**CALIFORNIA COASTAL COMMISSION**

**Item Tu 15i****STAFF REPORT: REGULAR CALENDAR**

**APPLICATION NUMBER:** 5-00-396

**PROJECT LOCATION:** 25 Brooks Avenue, Venice, City & County of Los Angeles

EXHIBIT # 4  
PAGE 2 OF 12

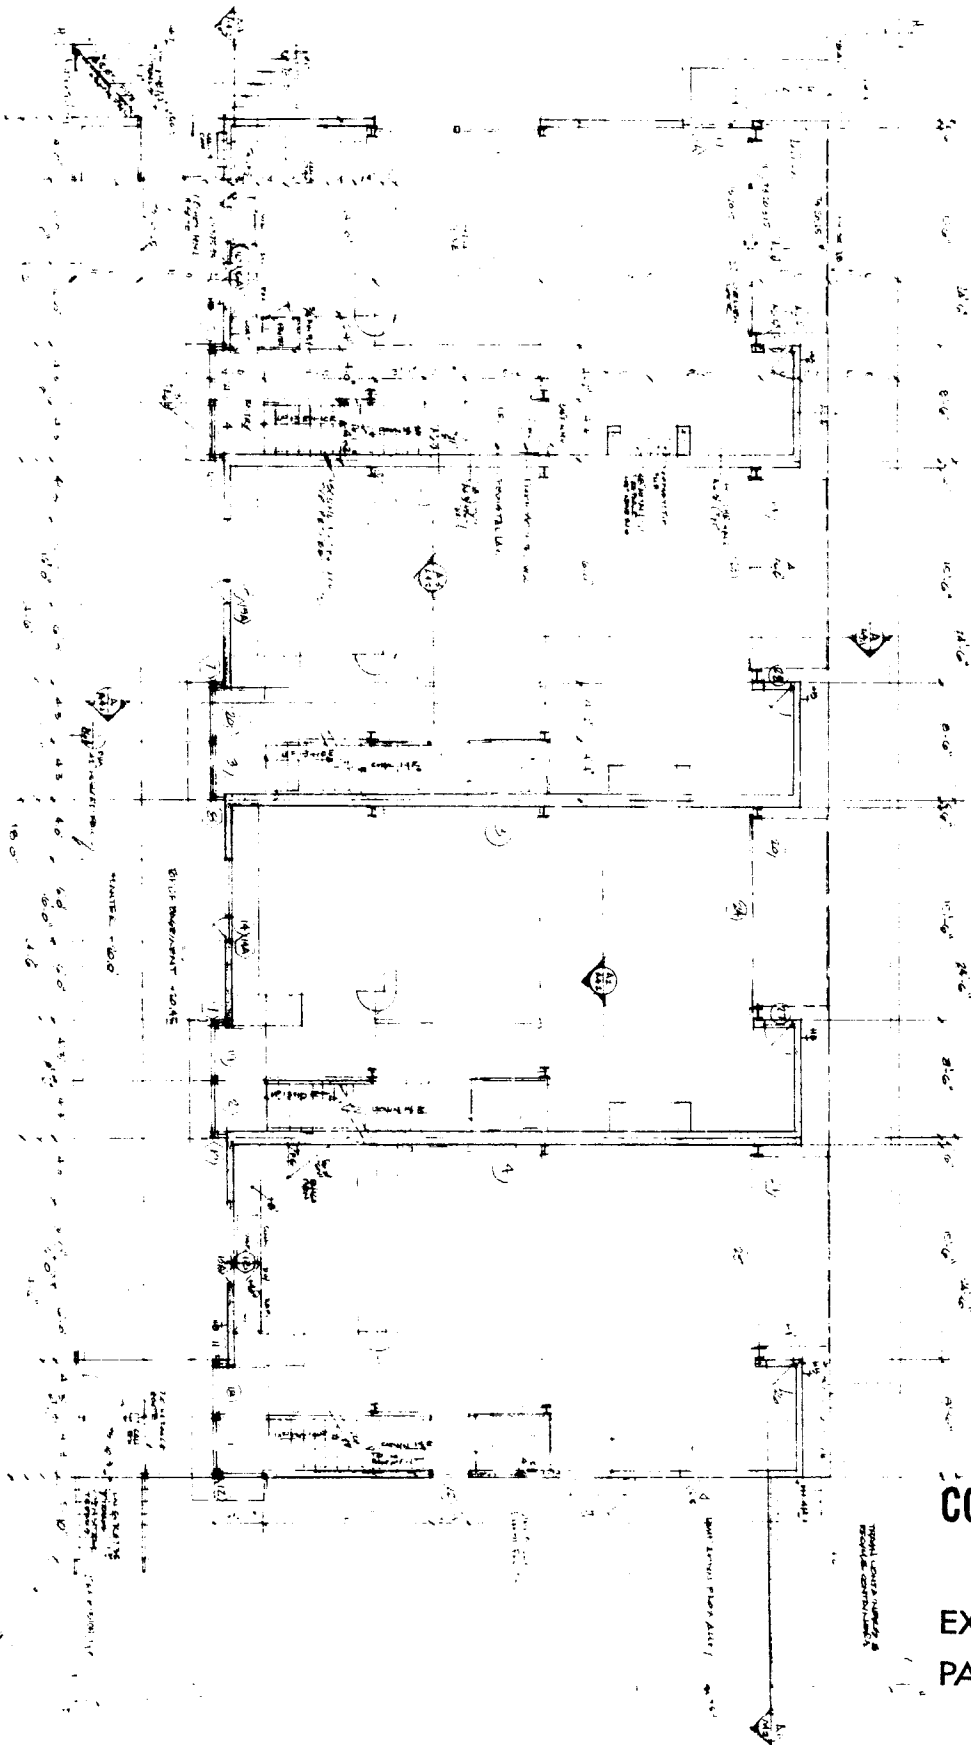
The applicant proposes to provide twelve on-site parking spaces, eight spaces within a semi-subterranean basement having four two-car garages, and four unenclosed spaces at the northern end of the lot (Exhibit #4, p.2). Vehicular access to the parking areas is proposed from Park Court (Exhibit #4, p.1). The twelve proposed on-site parking spaces provide an adequate parking supply for the residents of the proposed four-unit condominium and exceed the residential parking requirements of the LUP by three spaces. Therefore, the proposed project conforms to the Commission's residential parking standards for the North Venice subarea.

A minimum of nine parking spaces (two spaces for each dwelling unit plus one guest parking space) shall be provided and maintained on the site to serve the approved multiple family residence. Three parking spaces, in addition to the nine required to meet the needs of residents, shall be provided on the property, which is located in the Beach Impact Zone (BIZ), as required by the Venice Specific Plan Ordinance No. 172,897.

EXHIBIT # 4  
PAGE 6 OF 12

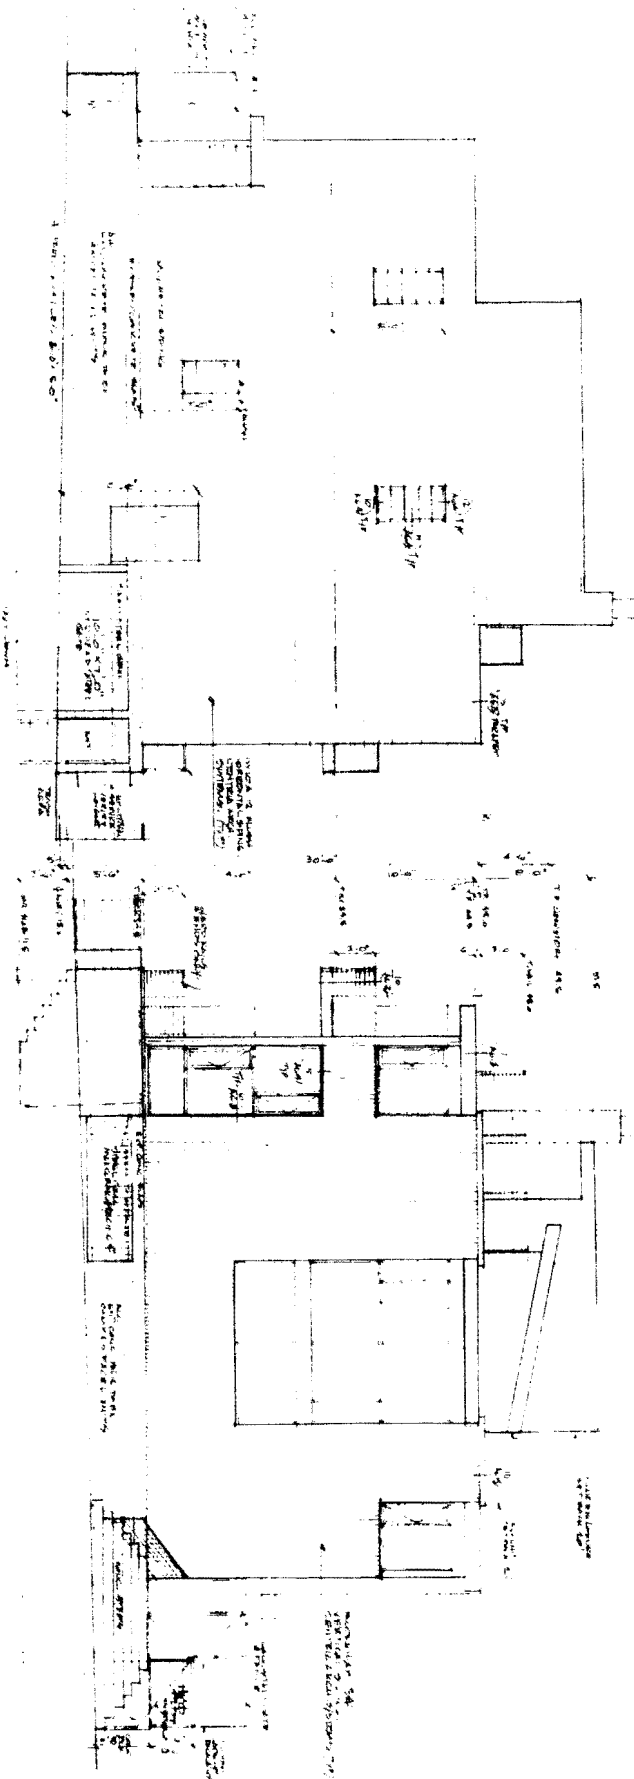
- (1) Increased the size of the middle window by extending it closer to the ground floor, and added mullion (a vertical strip, bar or pier dividing the panes of a window) (Exhibit #4, p.6),
- (2) Added larger overhangs above the windows to increase depth and break up the façade,
- (3) Provided landscape plans to landscape the front yard area (with the exception of the areas of the proposed stair enclosure at the western side of the property and the unenclosed stairway at the eastern corner of the property) (Exhibit #4, p.12); and
- (4) Introduced horizontal siding to break up the massing of the building façade.

The original proposal included four windows facing Brooks Avenue. After staff informed the applicant of the LUP land use and development standards for consolidated lots, the plans were revised such that the heights of two of the front windows were increased (Exhibit #4, p. 6). The current proposal for the four windows meets the LUP requirement of frequent windows. The other standards of the LUP are not met in the current project proposal. The project has been conditioned to meet those standards. Since the special conditions require submittal of revised plans consistent with the standards, the project has been conditioned to retain a minimum of four windows as currently proposed in order to maintain consistency with the LUP requirement of frequent front windows.

project, it is not feasible to have the roof access structures parallel to the neighboring lots, such that only the 5-foot width would be seen from Brooks Avenue. The front facing roof access structure is set back 20 feet from the front of the proposed building. This setback meets the requirement of the Venice LUP to set back any portion of a structure that exceeds 30 feet in height one foot for every foot in height above 30 feet. The other three roof access structures are identical in size and design to the first and are oriented directly behind the front-facing structure at approximately 20-foot intervals. The sides of the roof access structures will also be shielded from view from the public beach by the neighboring buildings. Each roof access structure has an 85-square foot area plus a flat roof that extends horizontally to the chimney four feet in front of the structure's doorway (Exhibit #4, pp.6, 9).

Prior to issuance of the coastal development permit, the applicant shall submit for the review and approval of the Executive Director revised project plans that incorporate the following: a) the building façade on Brooks Avenue shall be varied and articulated to a pedestrian scale using frequent windows, a well-defined street level entrance to the front residential unit, a minimum of one porch, bay and/or balcony in order to provide visual interest to pedestrians, b) the front and side yards shall remain open to pedestrian view and shall be improved with grade level landscaping in order to provide an area for on-site percolation and to provide visual interest to pedestrians; and c) the retaining walls, guardrail,

EXHIBIT # 4  
PAGE 7 OF 12

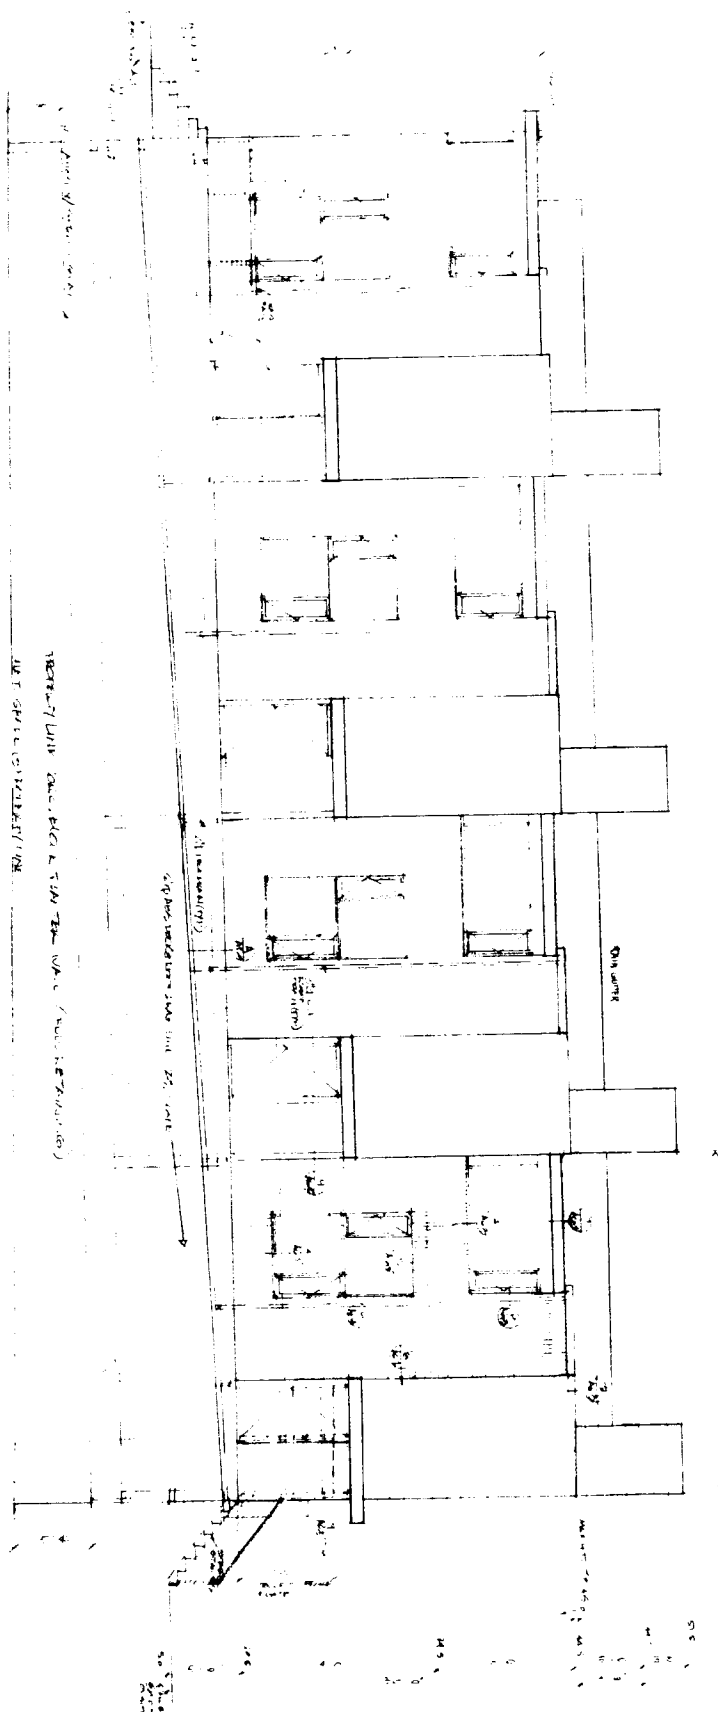
The current proposal does not include porches, bays or balconies fronting Brooks Avenue. The proposal includes one 70 square foot porch per residential unit on the top floor along the west side of the building (Exhibit #4, p.7). The front wall (5 foot wide by 3 foot high) of the front-unit porch, would be visible from Brooks Avenue (Exhibit #4, p.6). The porch, however, is oriented to the west side of the property and would not provide interaction between the residents and the neighborhood, nor would it provide visual interest to pedestrians. The majority of the front-unit porch (14 feet long) faces the residential building west of the property. The project has been conditioned to add a minimum of one porch, bay or balcony to the façade of the front residential unit.

In order to ensure that the proposed project preserves the unique character and pedestrian scale of the lots in North Venice, the approval of the permit is conditioned to require revised plans that incorporate the following: a) the building façade on Brooks Avenue shall be varied and articulated to a pedestrian scale using frequent windows, a well-defined street level entrance to the front residential unit, a minimum

of one porch, bay and/or balcony in order to provide visual interest to pedestrians, b) the front and side yards shall remain open to pedestrian view and shall be improved with grade level landscaping in order to provide an area for on-site percolation and to provide visual interest to pedestrians; and c) the retaining walls, guardrail, planters/fill, east corner stairway, galvanized steel gates (at the front and back of the east side-yard) and fence shall be removed from the project plans to provide a continuous yard at the same grade level as neighboring yards.

EXHIBIT # 4  
 PAGE 12 OF 12

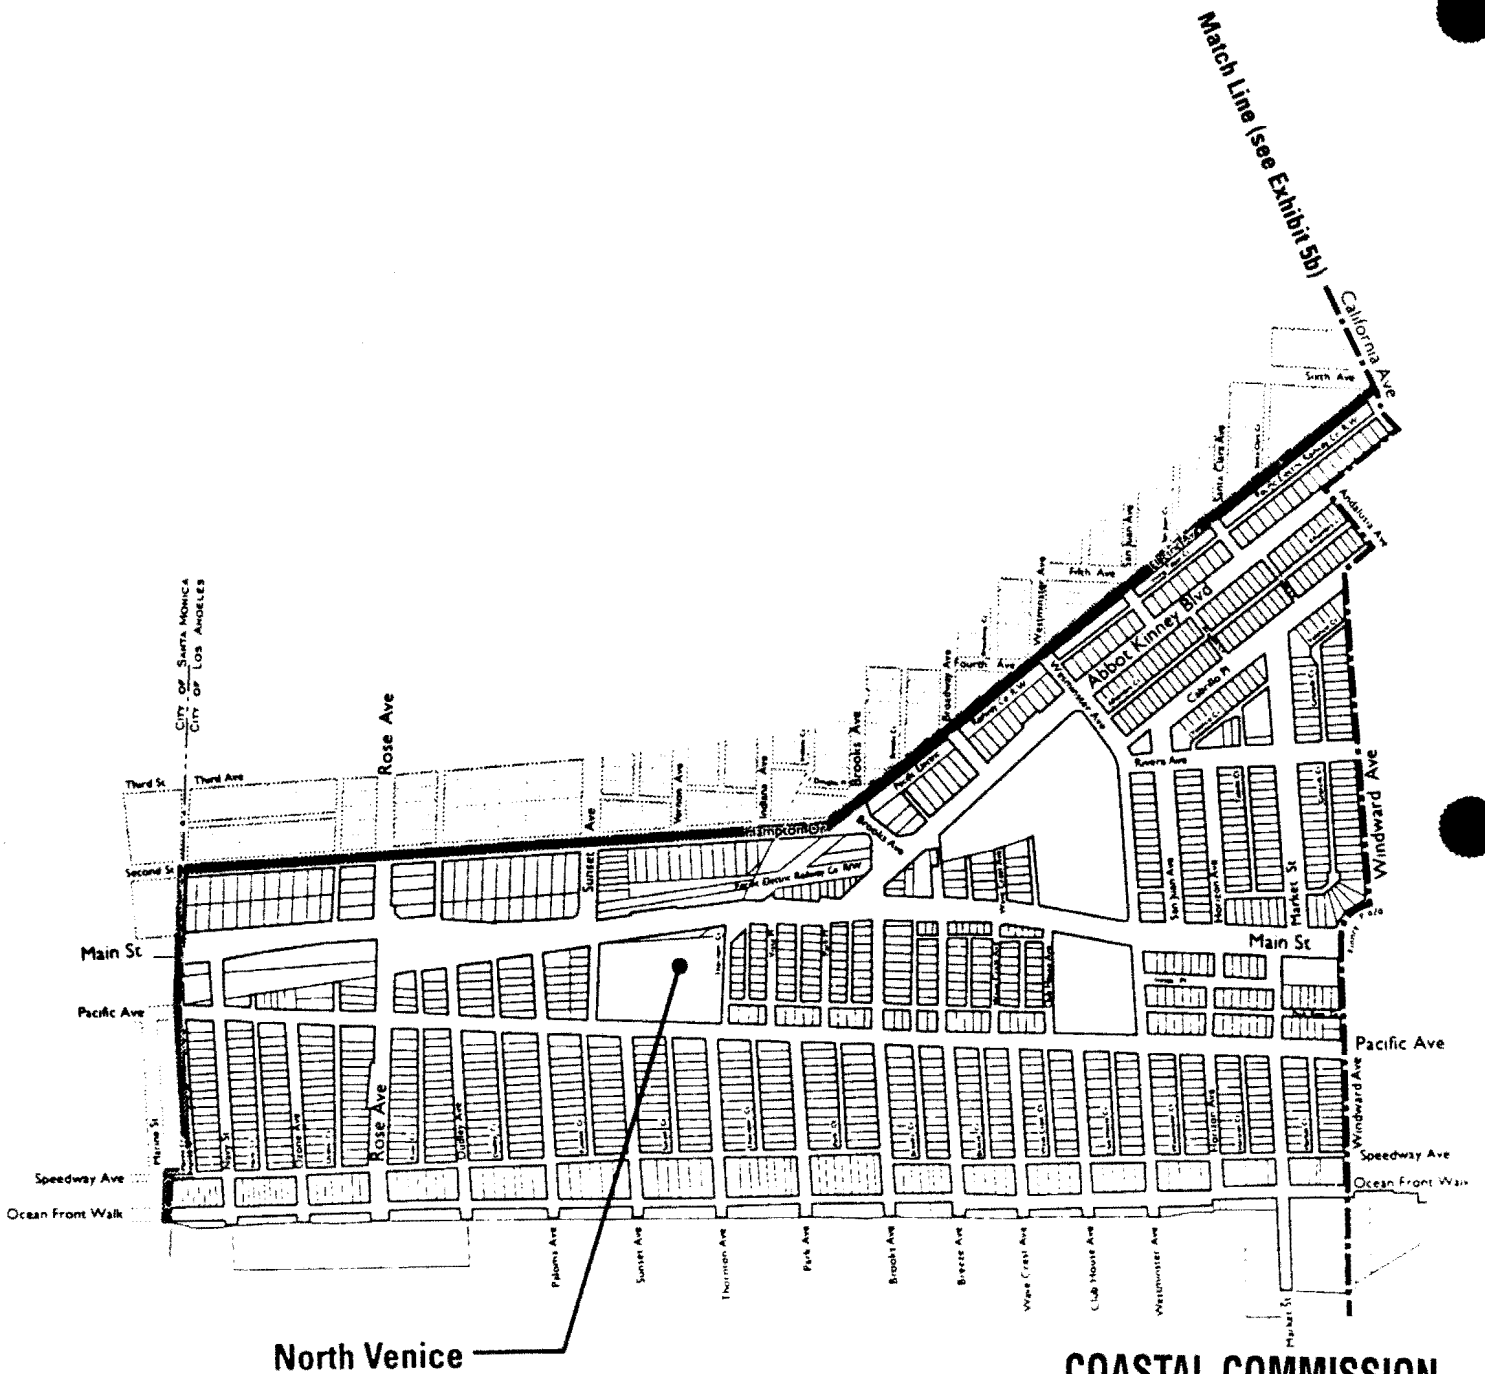
reduced front yard setback there is less area for landscaping. The front yard landscape plans include grade level landscaping with dense Sheep Fescue (*Festuca ovina glauca*) and numerous bunches of Deer Grass (*Muhlenbergia rigens*), as well as two Cordyline (*Cordyline australis*) in front of the proposed building (Exhibit #8). Two areas of the front yard would not be landscaped due to proposals to have a stair enclosure at the western end and an unenclosed stairway ascending to the gate at the eastern corner.

The side-yards are above grade on fill that is supported by concrete retaining walls along the western and eastern property lines and perpendicular to the multi-family residence at the front and back of the structure. The end of the western retaining wall closest to Brooks Avenue would be 3 feet 6 inches high. (Note: The applicant informed staff of a correction to the plans, stating that the western retaining wall would be 3 feet 6 inches high, rather than 5 feet 6 inches high, as currently drawn on the plans (Exhibit #4, p.6)). The landscape plans include planting of 25 Oldham Bamboo (*Bambusa oldhamii*) in the west side-yard on fill at the height of the retaining wall. The end of the eastern retaining wall closest to Brooks Avenue would be 3 feet 8 inches high, have a concrete stairway leading up to it, a 3 foot 6 inch high guard rail above it, and a 7 foot high galvanized steel gate and fence set back 4 feet from the top of it. The retaining wall and gate/fence would have a combined height of 10 feet 8 inches (Exhibit #4, p.6). The landscape plans include planting of 24 Oldham Bamboo plus Big Blue Lily Turf (*Liriope muscari*) throughout the east side-yard in fill at the height of the retaining wall.

The project is conditioned such that the side-yard landscaping is planted and maintained at grade level. The condition requires the maintenance of a landscaped view corridor through the side-yards. This must be achieved by the applicant submitting and using revised plans that remove the retaining walls, guardrail, planters, east corner stairway, galvanized steel gates (at the front and back of the east side-yard) and fence. The condition requires planting of the vegetation in the locations proposed, but directly in the ground rather than in fill. Maintaining grade level landscaping in the side-yards, as well as in the front yard (with the exception of the stair enclosure at the western end of the front yard), would provide a continuously landscaped yard at the same grade level as neighboring yards. By having a continuous yard at the same grade level as neighboring yards, the distance between the subject building and the two neighboring buildings would appear greater than if there were planters and retaining walls between them. Maintaining landscaped space between the subject building and the two neighboring buildings, would provide more of a residential scale than the proposed 2 foot 6 inch to 10 foot 8 inch high barriers facing Brooks Avenue.
